Loud fan noise**Models: FAN BLADE Part.No. 6299 905-02**Built into the following groups of appliances: (Concerns all versions)

Fault profile: Loud fan noises are caused by fan blade.

Fig. 1.0: Part.No. 6299 905-02

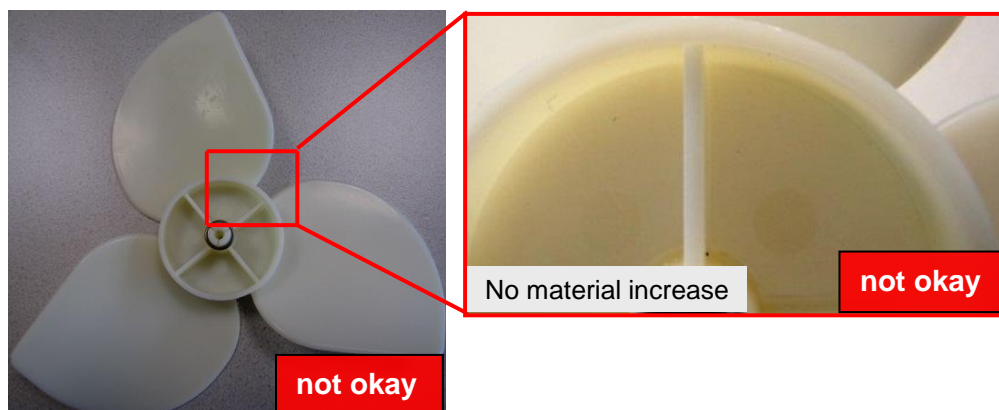
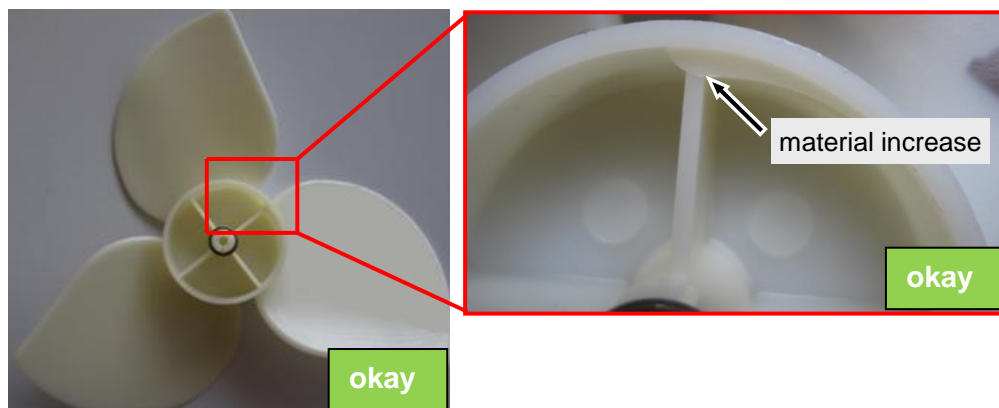
Cause: The inclusion of the fan blade to the motor shaft is not centered, so the fan is unbalanced.

To correct: Built in optimized fan blade:

Spare part	Until now	NEW
Fan blade	6299 905-02	6299 905-03

Note: Previous fan blade must not used anymore.
